# Traffic Engineering Report

Proposed Mixed-Use Development

At 26 Edmondstone Road, Bowen Hills

REVISED CONDITIONS - VARIATION 4  
REFERENCE EMAIL 02/06/20 FROM ETHOS URBAN

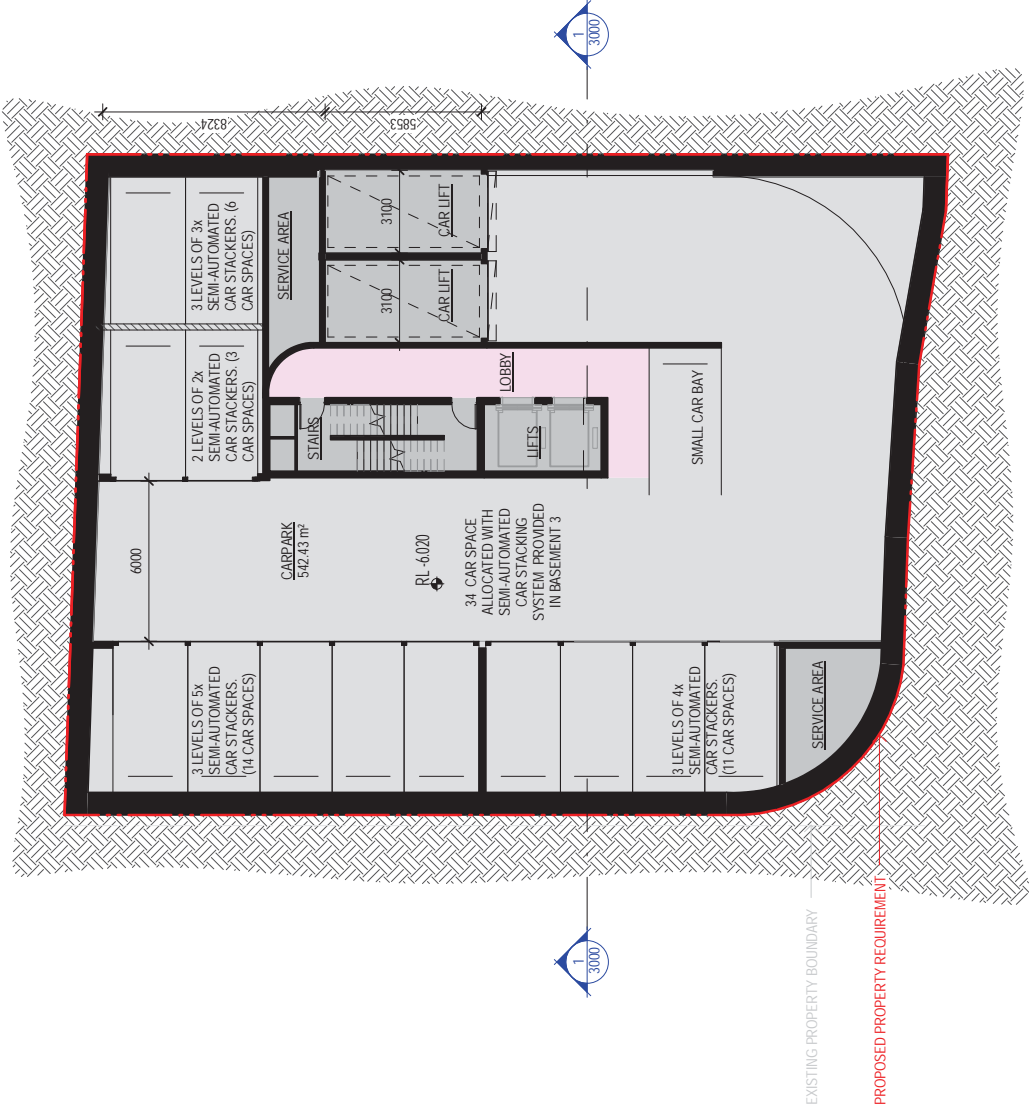
Delineate on the plans a 3.75m wide footpath (sidewalk) between the roadway (carriageway) and the property boundary for both the Edmondstone Road and Thompson Street frontages of the site.
- F3.

The driveway splay must not protrude past the northern property boundary of the site (i.e. into the area of the sidewalk adjacent to the northern property on Thompson Street). Amend the plans to taper or snake the driveway to ensure the entire driveway and splay remain wholly within the sidewalk adjacent to the property the subject of this application.
- F4.

Provide further detail about the visitor parking spaces for cars and bicycles located on Basement level 1 and 2.

F7.1 Include details of how residential and commercial visitors to the site will be advised on the availability of the visitor car spaces, including the number available at any particular point in time.

REFER TO UPDATED TTM REPORT DATED 23.06.2020
- F5.

ITEM F2.

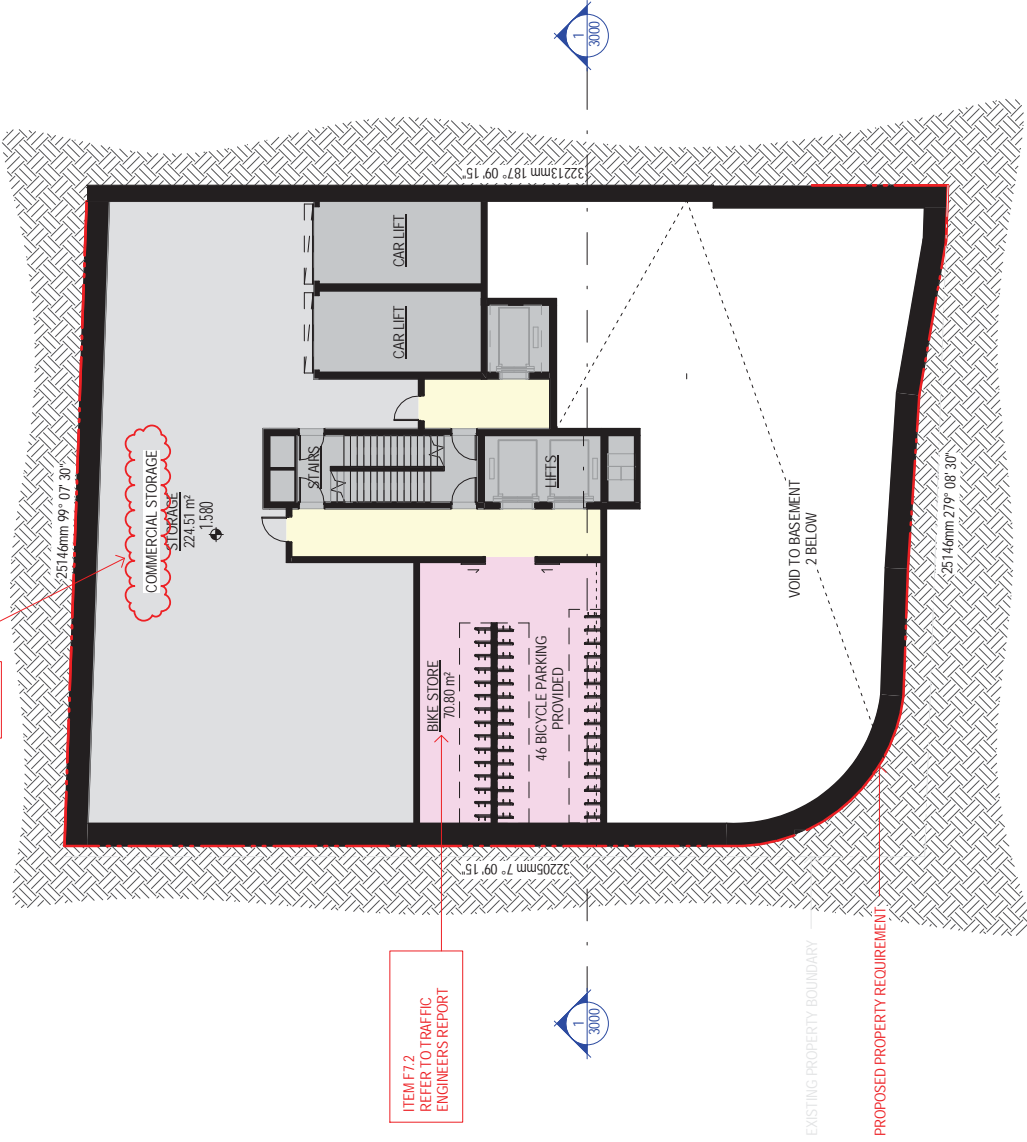
1. Ndate on the plans a minimum habitable floor level of 3.2m AHD
2. Remove the Preliminary Advice. Only stamp from plans in Appendix B TTM Drawing 18BRT0113-01 (Rev C) & 02 (Rev B) in the TTM report
3. The TTM report recommends MRV servicing for the showroom use. Demonstrate on the plans where the MRV bay or road point in accordance with TAPS is to be provided or provide justification on how MRV servicing can be managed.
4. The car stacker in Basement 3 level (-6.02 level shown) doesn't provide sufficient height to accommodate the 3 level car stackers, as detailed in the TTM report, within the nominated location.

- Confirm what use (i.e. commercial or residential) the 224.51m² storage area on Basement 1 is associated with.
- F2. Delineate on the plans a 3.75m wide footpath (sidewalk) between the roadway (carriageway) and the property boundary for both the Edmondstone Road and Thompson Street frontages of the site.

- F4. The driveway play must not protrude past the northern property boundary of the site (i.e. into the area of the sidewalk adjacent to the northern property on Thompson Street). Amend the plans to taper or snake the driveway to ensure the entire driveway and play remain wholly within the sidewalk adjacent to the property the subject of this application.

- Provide further detail about the visitor parking spaces for cars and bicycles located on
- F7. Basement level 1 and 2.
- F7.1 Include details of how residential and commercial visitors to the site will be advised on the availability of the visitor car spaces, including the number available at any particular point in time

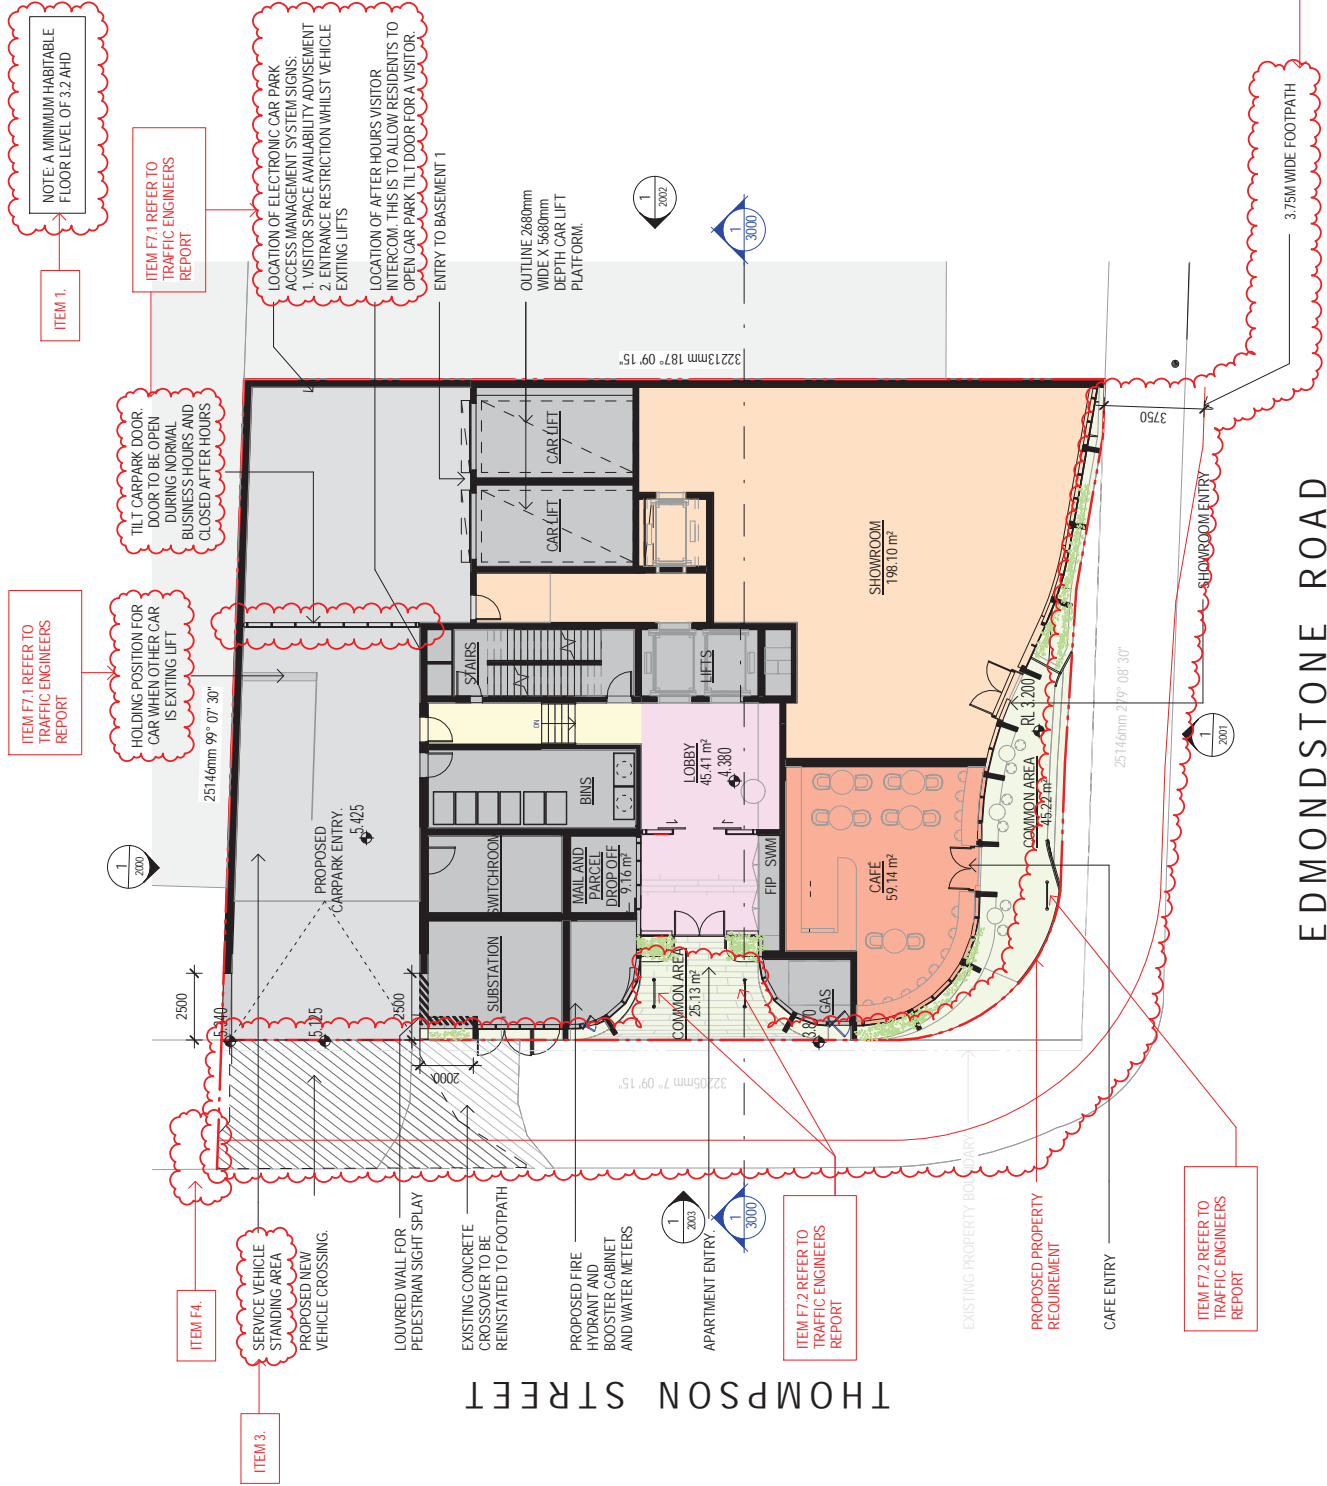
F7.2 Bicycle parking is to be provided in accordance with TAPS requirements.

F8. Provide dimensioned plans for accessible units demonstrating accessibility in accordance with EDO Guideline 2: Accessible Housing.

**REFER TO UPDATED TTM REPORT DATED 23.06.2020**

PROJECT NUMBER	ORIGINAL SIZE
18BRT0113	A3
DRAWING NUMBER	REVISION
18BRT0113-01	D
DATE	SHEET
22 Jun 2020	1 OF 2

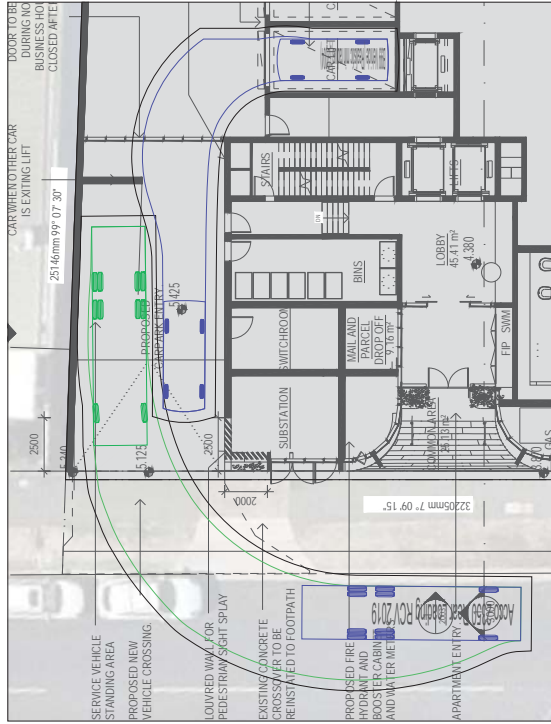
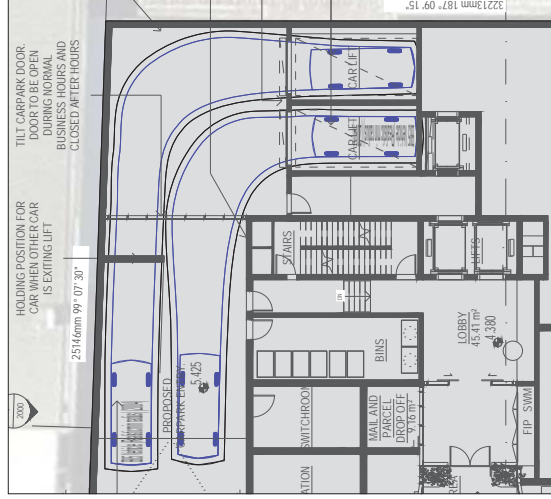
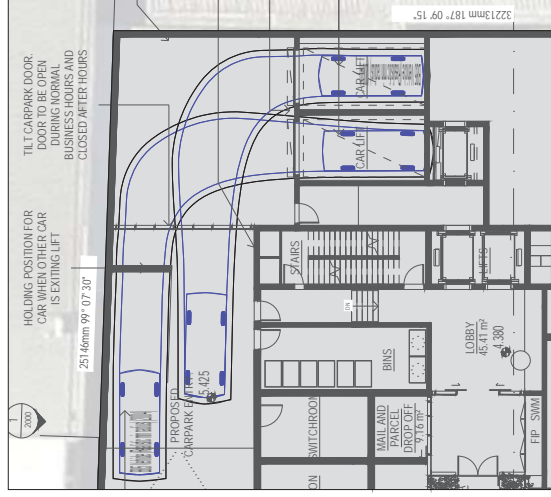
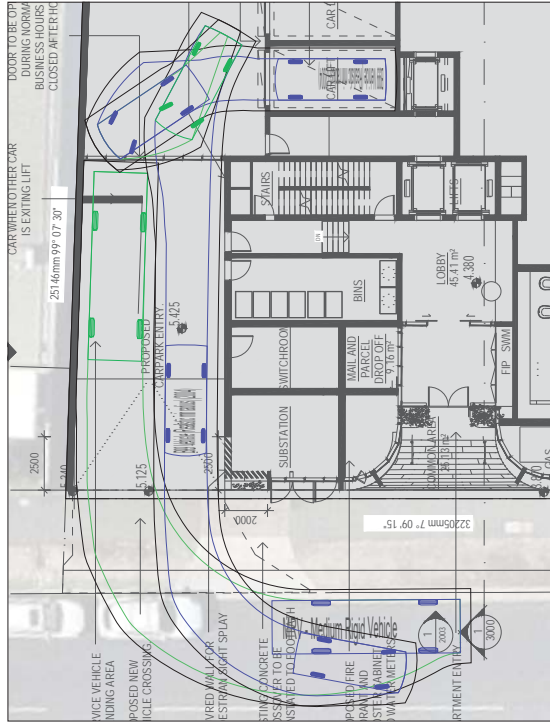
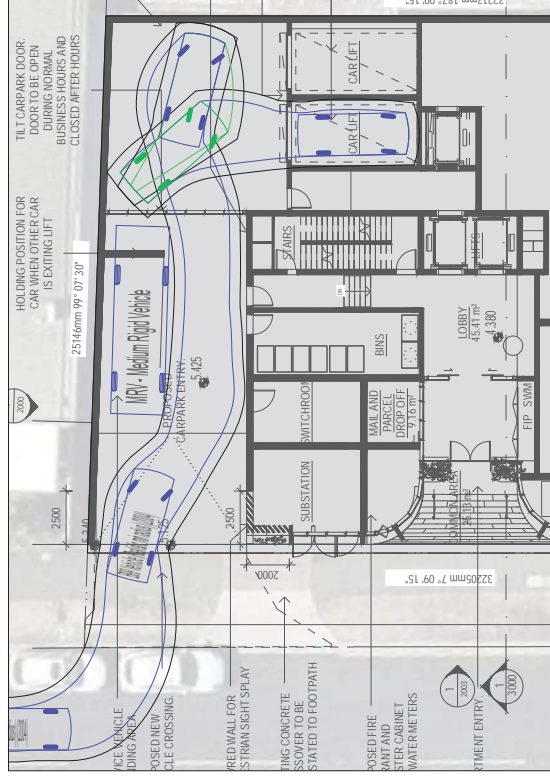
Remove the Preliminary Advice. Only stamp from plans in Appendix B TTM Drawing 188RT0113-01 (Rev C) & 02 (Rev B) in the TTM report

The TTM report recommends MRV spacing for the showroom use. Demonstrate on the plans where the MRV lay or hold point in accordance with TAPS is to be provided or provide justification on how MRV servicing can be managed.
4.

TTM Drawing 18BRT0013-01 (Rev D), included in **Appendix B**, demonstrates the relevant vehicular swept paths of the design vehicles including the provision for passing opportunities for cars entering/exiting the car park lifts whilst a service vehicle is temporarily standing on the driveway area.

PROJECT	PROJECT NUMBER	ORIGINAL SIZE
18BRT0113	18BRT0113	A3
DRAWING TITLE	DRAWING NUMBER	REVISION
SWEPT PATH ANALYSIS - BASEMENT 2	18BRT0113-02	C
DATE	DATE	SHEET
22 Jun 2020	22 Jun 2020	1 OF 1

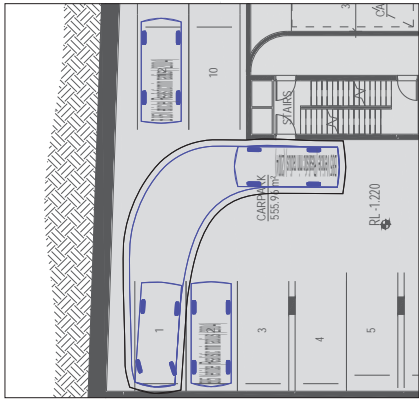
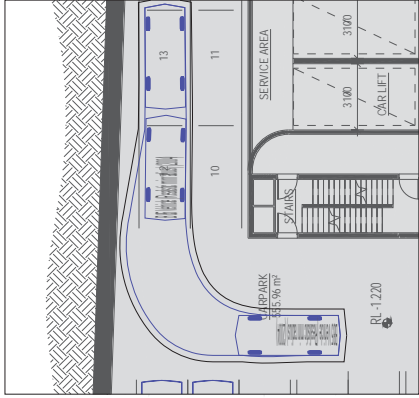
Whilst the proposed aisle extension on Basement 2 does not satisfy the 1m requirement under ‘AS2890.1’, the provision is suitable to cater for the end parking spaces. To demonstrate the suitability of the end aisle provision, TTM have undertaken a swept path analysis showing entry and exit manoeuvres to car parks #1 & 12/13 (TTM Drawing 18BRT0113-01 Rev D, included in **Appendix B**).
